VKM 60014

Technical Bulletin - March 2010

Chevrolet Aveo, Kalos, Lacetti, Nubira, Optra

Technical Information: VKM 60014

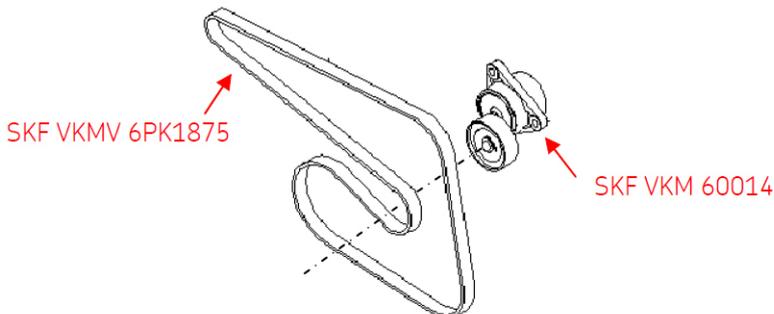
Chevrolet OE tensioner 96349976 is obsolete and replaced by 96966707. This latest design is offered by SKF as Kit VKM 60014.

Chevrolet 96349976 (Old designs)

SKF VKM 60014 (Latest design)

Metal Pulley

Plastic Pulley

Both plastic and metal pulley version of Chevrolet 96349976 can be replaced by the new version of SKF VKM 60014. This Tensioner should be used in conjunction with SKF VKMV 6PK1875 (Chevrolet 96183108 & 96990678) to provide the exact fitting replacement on the above car applications.
